LIGO LABORATORY

MEMORANDUM

DATE: 5 Nov 2021
TO: GariLynn Billingsley
CC: Peter Fritschel, Slawek Gras, Calum Torrie
FROM: Dennis Coyne
SUBJECT: Waiver: Sputtered Contamination on the A+ ITM 05 Barrel
Refer to: LIGO-Q2100038-v1

Figure 1 sputtered contamination on the A+ ITM 05 Barrel

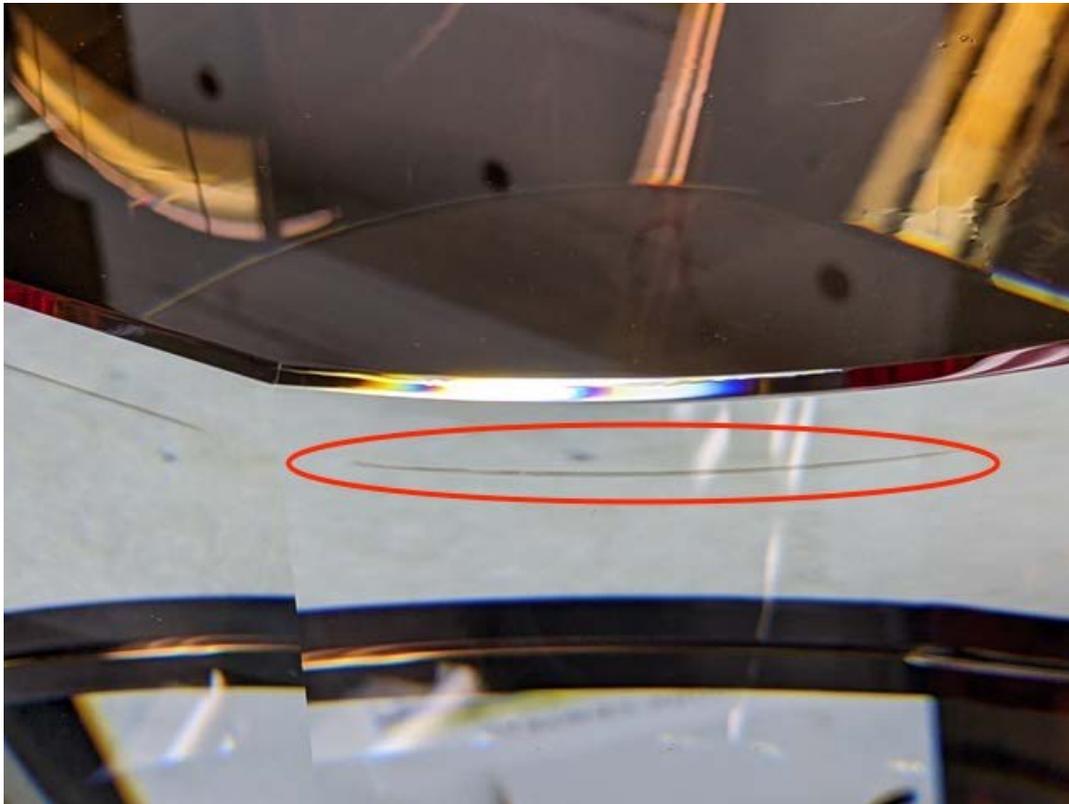
On Oct 27, 2021 our polishing contractor, Zygo, informed us that after finishing the processing on ITM 05, and removing their tooling, they noticed a line of sputtered contamination on the cylinder/side flats about 1 cm from the R1 surface; see Figure 1. This is a direct result of the unusually large amount IBF work on this optic. It is likely that the other optics have some of this contaminant as well, though much less due to less IBF work.

The contamination line on the barrel does not present any optical issues.

Since the contamination is an extremely small quantity of pyrolyzed Delrin residue (carbon, possibly containing some nitrogen, silicon or oxygen) it does not present a vacuum outgassing issue.

The presence of a material on the low loss fused silica test mass substrate could potentially add to the displacement thermal noise floor (strain noise). An analysis¹ of the

effect of a 100 nm layer of gold on the entire barrel of a test mass indicates that the effect is ~1% increase in the strain noise Amplitude Spectral Density (ASD). We can use this analysis to get an estimate of the effect of the sputtered contaminant. The plots of strain energy density indicate approximately uniform strain energy density along the barrel (to within a factor of ~4). Assuming spatially uniform strain energy density, and similar elastic modulus for the contaminant and gold, then the total strain energy (normalized by the force amplitude squared) for the contaminant line on the barrel is

In the referenced analysis, the presumptive gold barrel coating, with a loss factor of 0.009, resulted in ~1% increase in the strain noise ASD. The contaminant line is comprised of a very hard residue with likely a much lower loss factor. Consequently, the effect of the contaminant line is not consequential and the optic can be accepted without removal of the contaminant.

Figure 2 Strain energy density on a TM with flats on the barrel (credit: Slawek Gras)

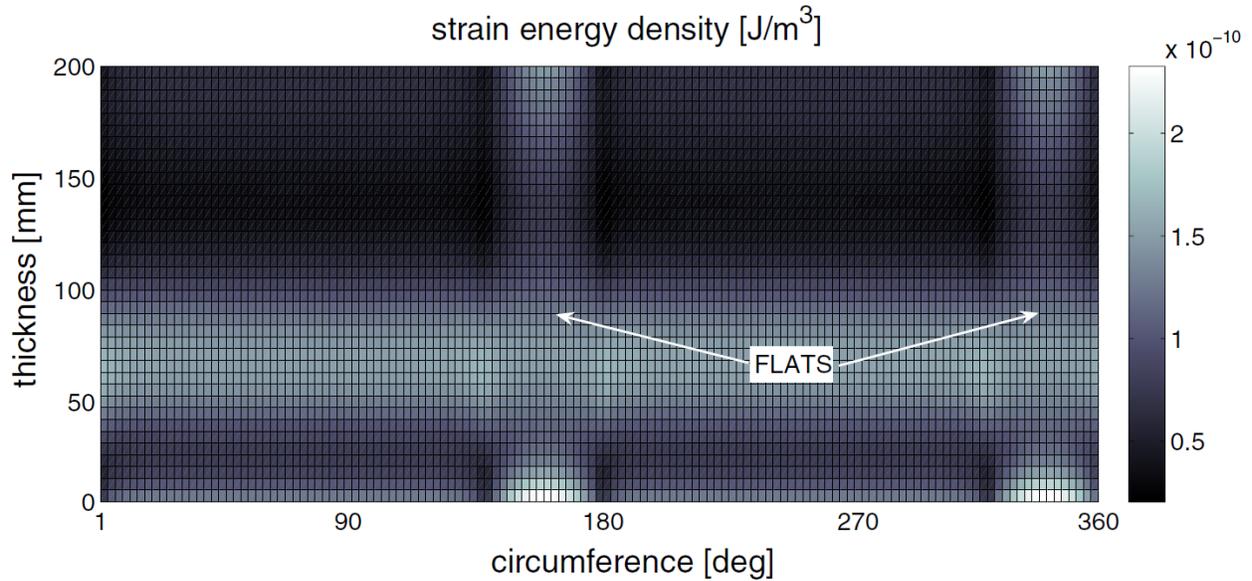
Note: The referenced analysis assumed an axisymmetric test mass (without flats). The strain energy density plot above for an optic with flats is in rough agreement with the strain energy density plot in the referenced analysis. The strain energy density at the contamination line (at ~10 mm from the front surface) is higher than on the cylindrical barrel by a factor of ~2.
